Re: Van Horn Potable Water Reservoir Improvements
Pullman Change Proposal 598790-01 – Roof Topping Slab

TITLE:
GENERAL ARRANGEMENT OF RESERVOIR (PRIOR TO RESURFACING, AFTER DEMOLITION OF EXISTING SURFACE)

TITLE:
CONCRETE ROOF RESURFACING DETAILS

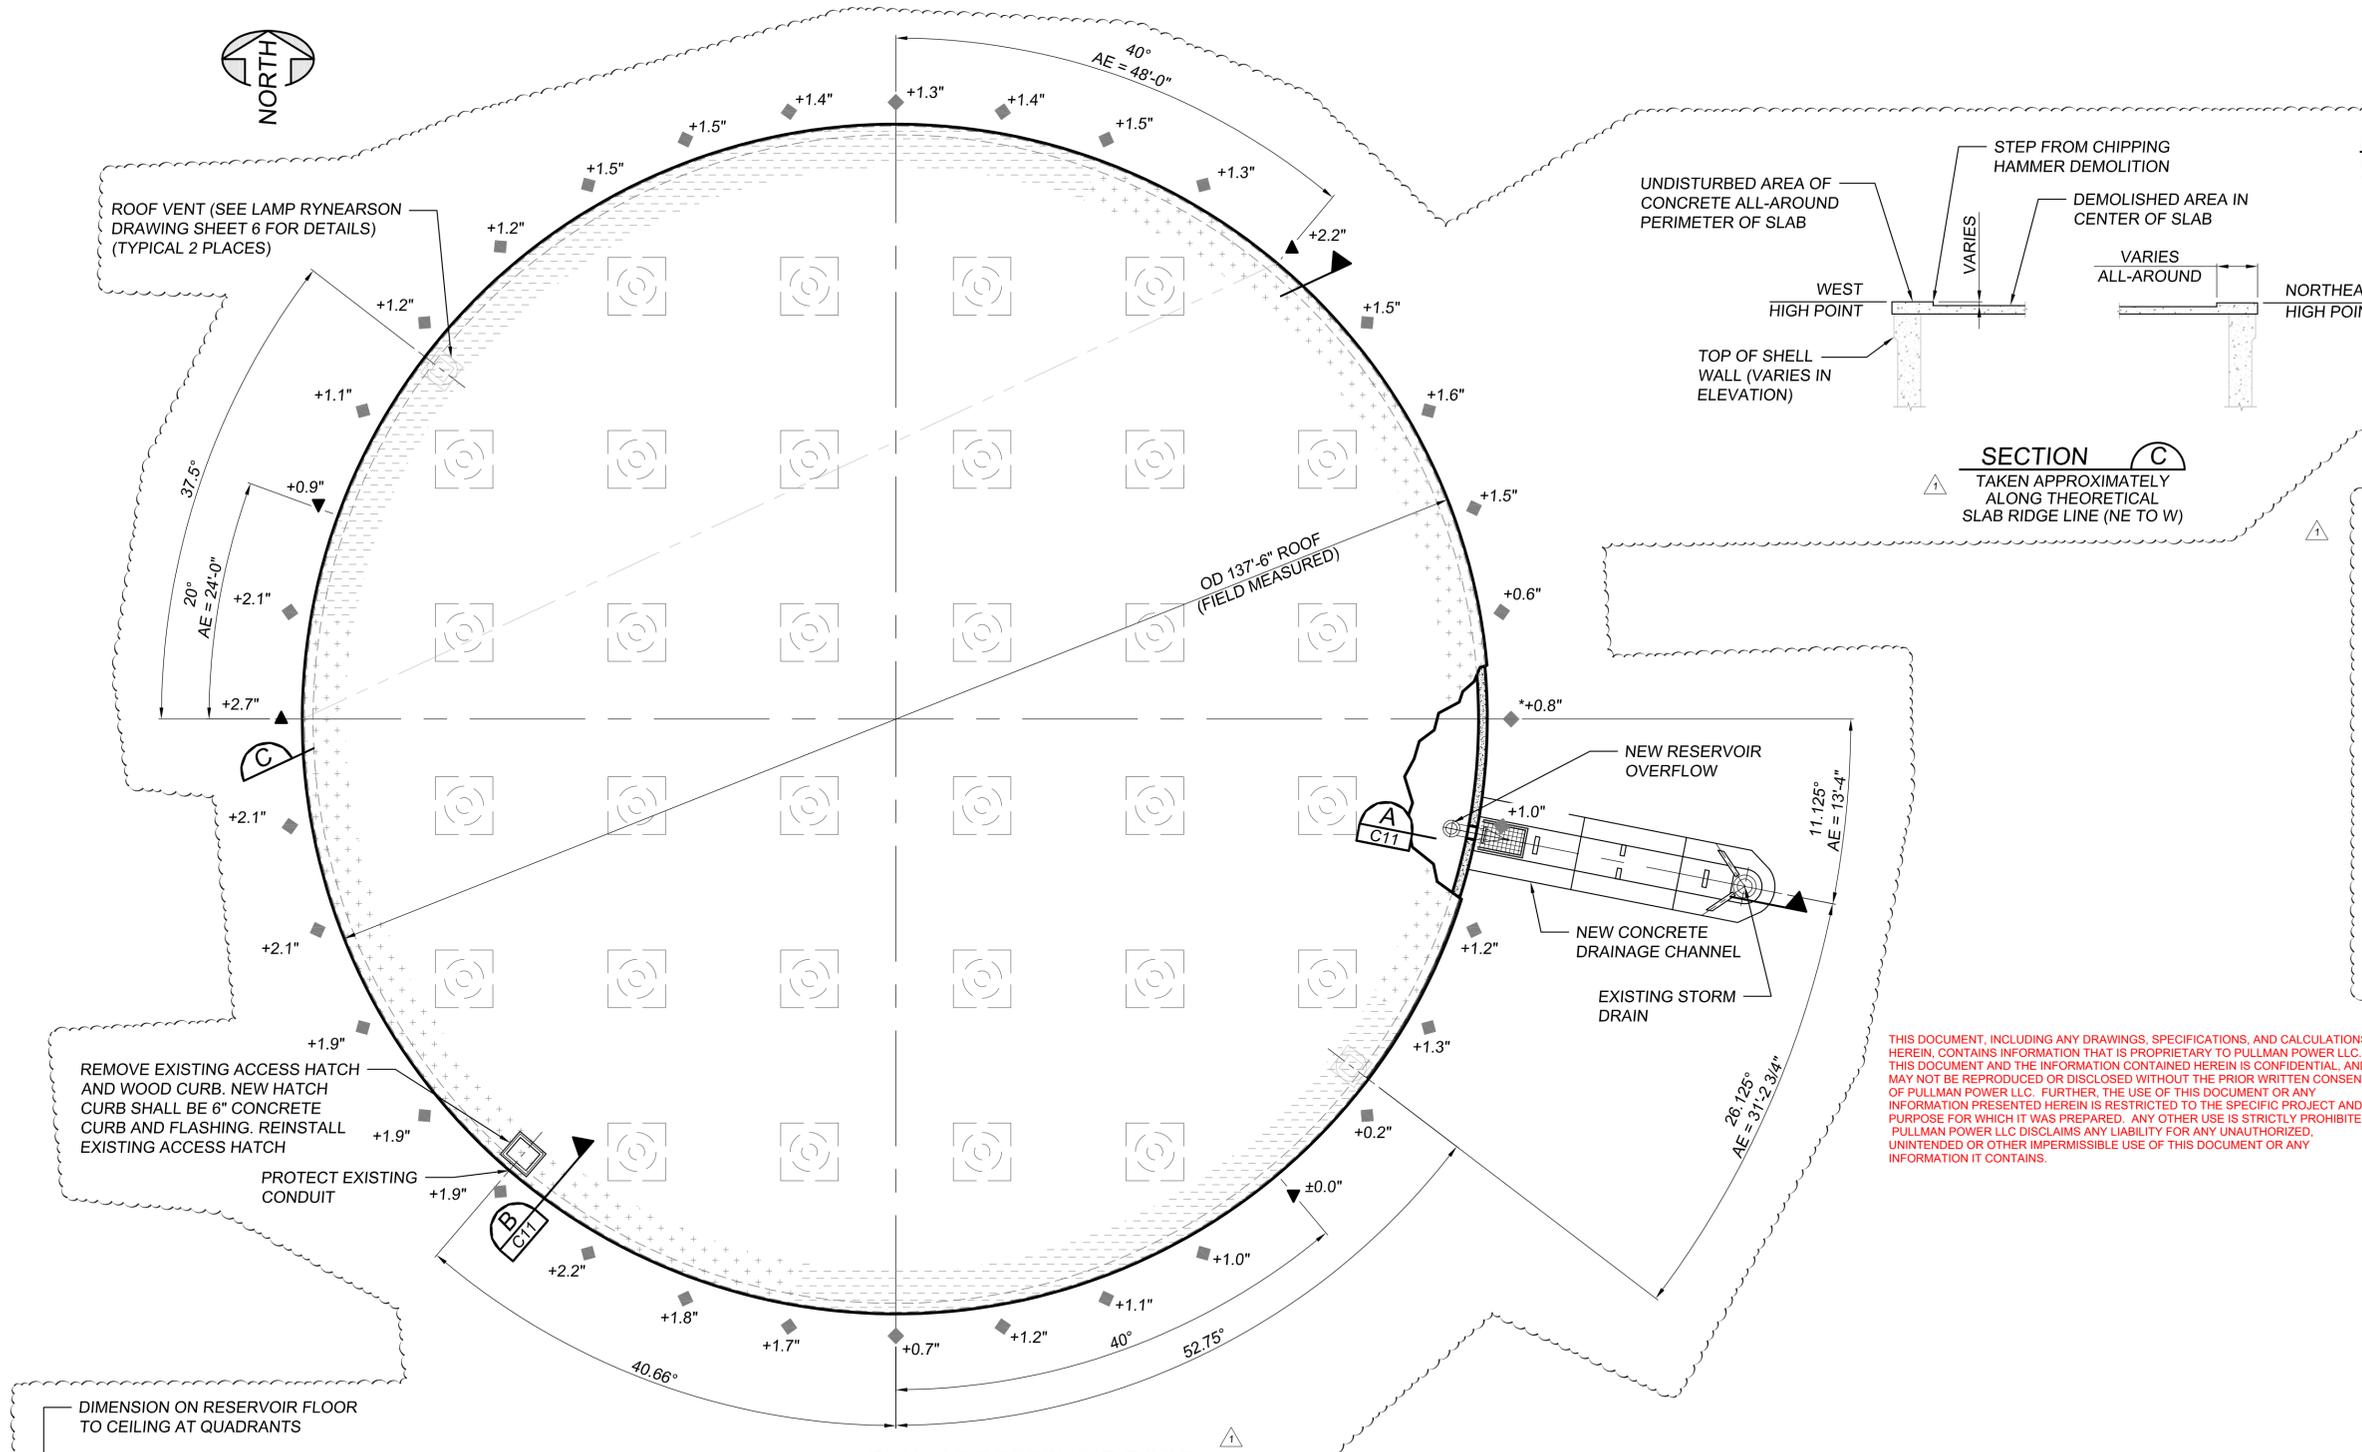
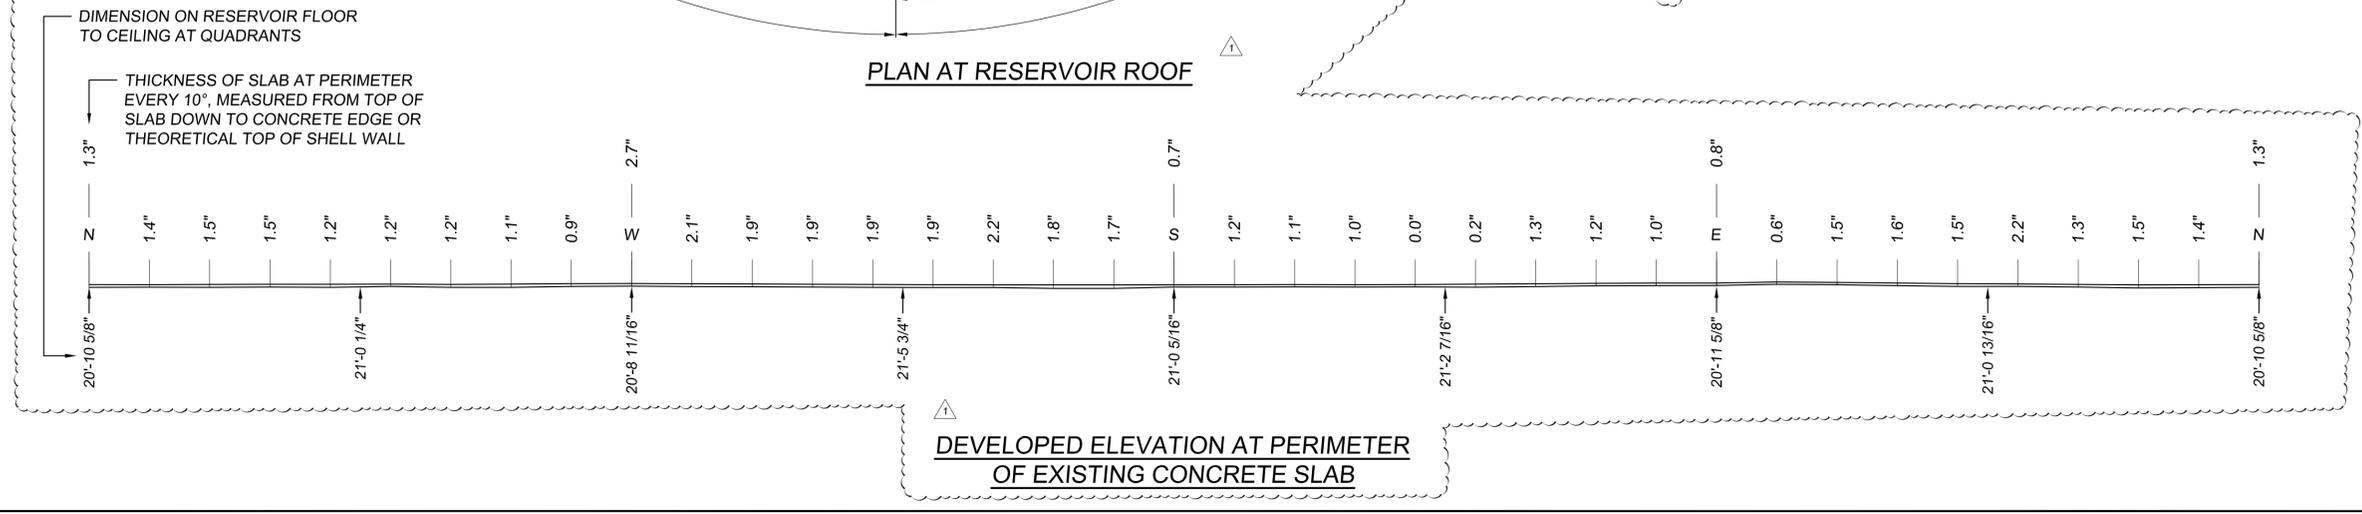
PULLMAN has provided preliminary Drawing Sheet C01 to illustrate a general arrangement of the reservoir including a developed elevation view of the perimeter curb. **In summary, the low points around the curb vary, which are referenced on the drawing as +/-0". The theoretical high line across the slab goes from northeast to west centerline with the highest east point at +/-2.2" and the highest west point at +/-2.7".**

The laser scan survey data results for the roof slab are not entirely complete yet, but some preliminary results indicate that there is not a definitive slope built into the existing slab and the slab is relatively flat in nature (other than surface irregularities caused by previous roof repairs). PULLMAN has therefore **presented the most accurate thickness of concrete (based on the**

TITLE: GENERAL ARRANGEMENT OF RESERVOIR
ROOF REINFORCING STEEL

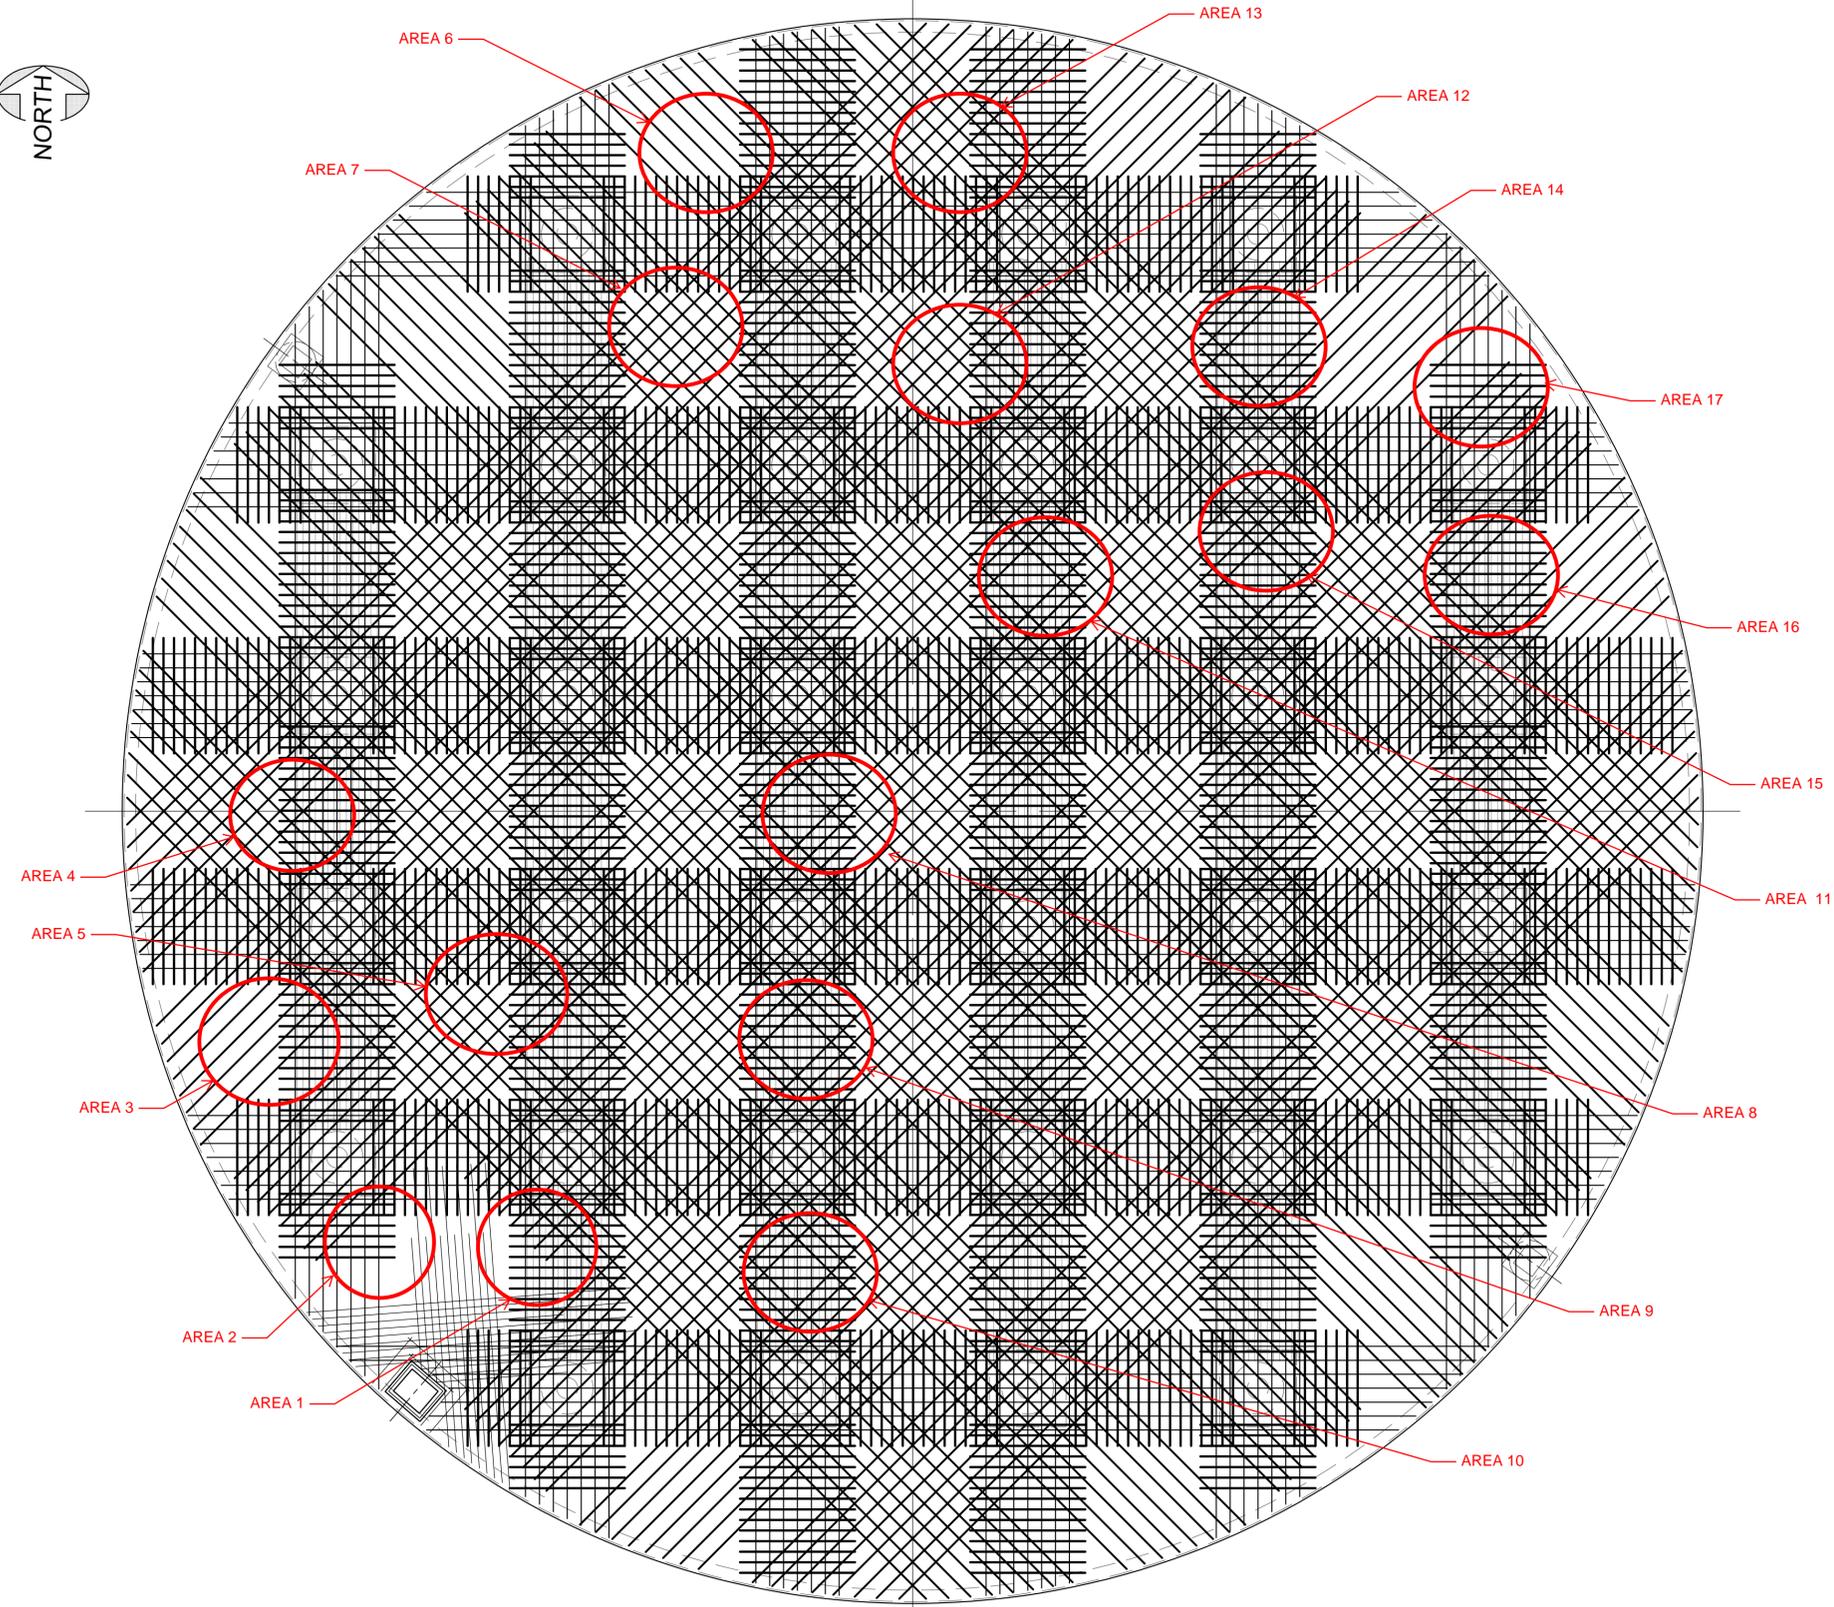
PULLMAN has also performed a condition assessment of the exposed reinforcing steel on the reservoir roof and provided a plan view of the roof to illustrate the locations of reinforcing steel exposing more than 50%. There was a total of 17 locations recorded and each location is estimated to be around 40 square feet. These areas will require chipping behind the exposed rebar then coating with anti-corrosion inhibitor. There has not been any supplemental rebar included within our proposal since this won't be determined until the rebar is fully exposed to measure the section loss.

- Recommendations:
 - Chip out additional concrete around rebar with more than 50% exposure. There are approximately 17 locations that will require additional concrete to be removed to fully expose the reinforcing steel. Any supplemental rebar required will be performed at the already established unit pricing.

- Any exposed rebar will then be cleaned and primed with Sika Armatec anti-corrosion inhibitor. PULLMAN has assumed 17 areas at approximately 40 SF each of rebar which will require cleaning and coating with anti-corrosion inhibitor.

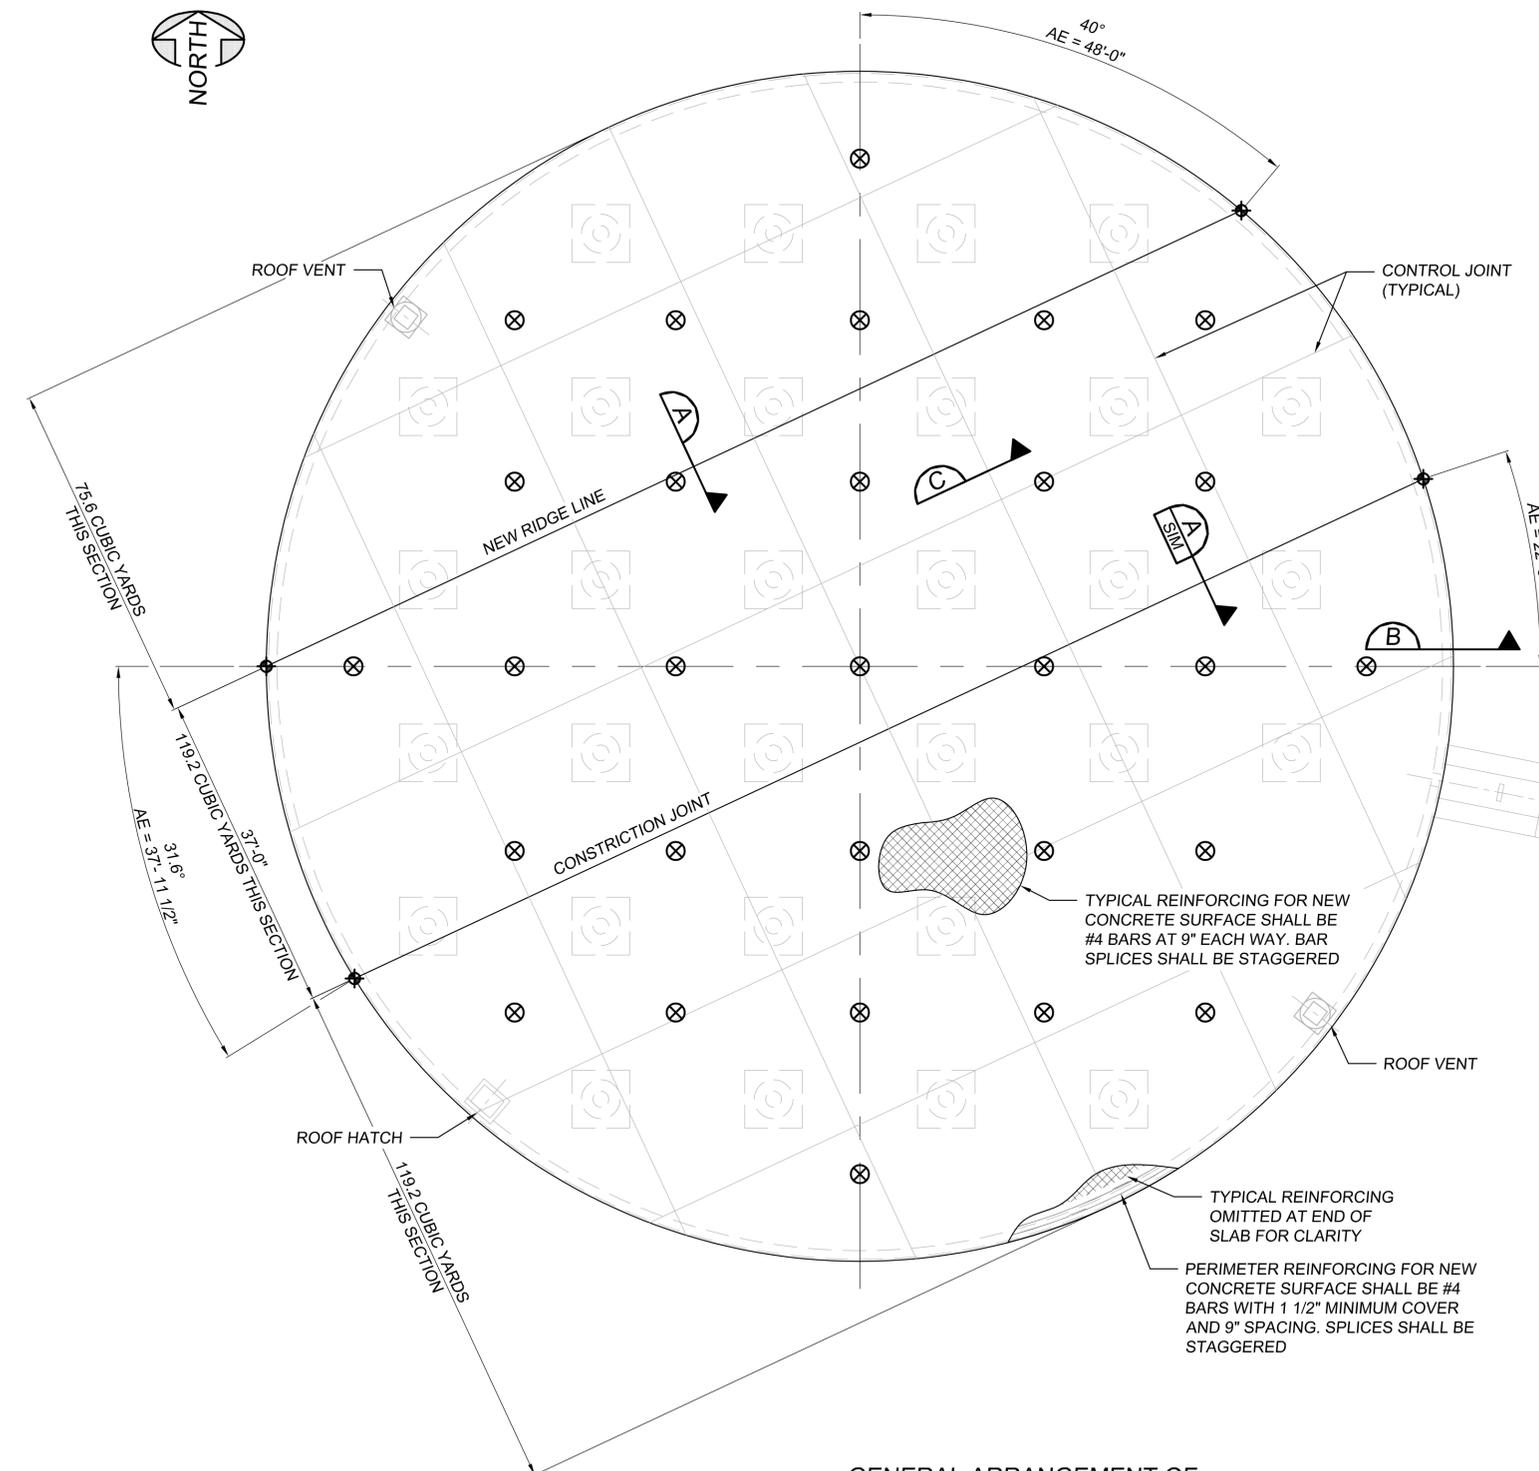
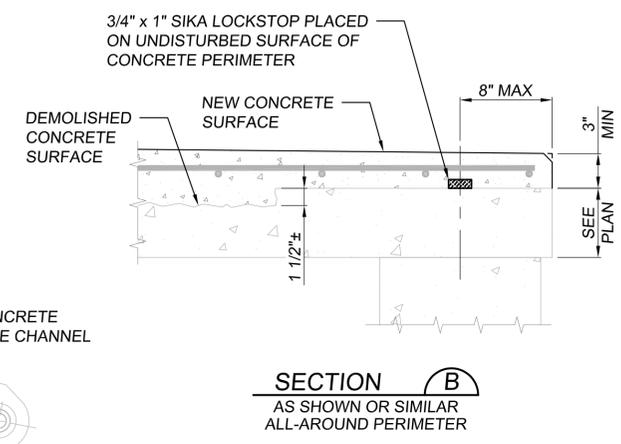
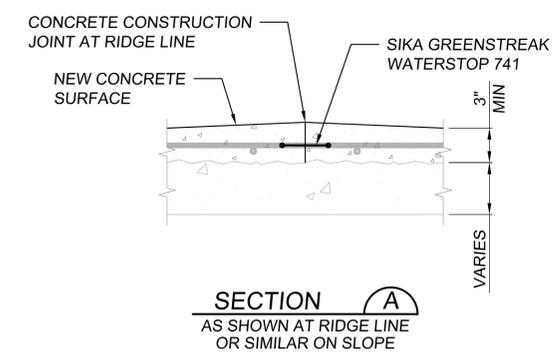
PULLMAN has described the repair process below and has also provided a preliminary detail per Drawing C13 for the concrete roof resurfacing details.

- 3/8" x 2-1/4" carbon steel Hilti Kwik bolts will then be installed at 18" O/C to tie into the existing slab and support #4 reinforcing steel installed on a 9" grid.

- A waterstop will be added around the perimeter curb before placing new concrete topping slab.
 - After calculating the additional loading to the reservoir roof caused by placing this new concrete topping slab, it was determined that shoring would be required beneath the slab before each placement. The shoring analysis assumed a uniform existing concrete roof slab thickness of 3 7/8". The shoring would be required in approximately 15 setups, essentially (2) post shores located at center spans between existing columns and between columns and tank walls, which would be moved appropriately ahead of each placement. Post shores will be braced for stability around existing columns.

- The topping slab will then be poured in the center and eight (8) sections to build a slope into the roof with a lightweight ready-mix concrete using a concrete pump truck. The new concrete topping slab would be placed all the way over the top of the existing perimeter curb to allow for proper drainage. The average thickness of this concrete overlay is assumed to be roughly 8.5" thick to achieve an approximate 1/8:12 slope (1% slope). **The estimated volume of concrete is 315**

cubic yards. PULLMAN believes that this average thickness can be reduced once completing the survey data results. It may be possible to slope the topping slab in the north and south direction starting at the theoretical high line and increasing the slope while still maintaining the appropriate cover along the slab and low points on the curb.

- This will require formwork to be installed for each placement section. A waterstop will be added between placements. Formwork will also be required around the perimeter curbing since the placement is being made over the curb.
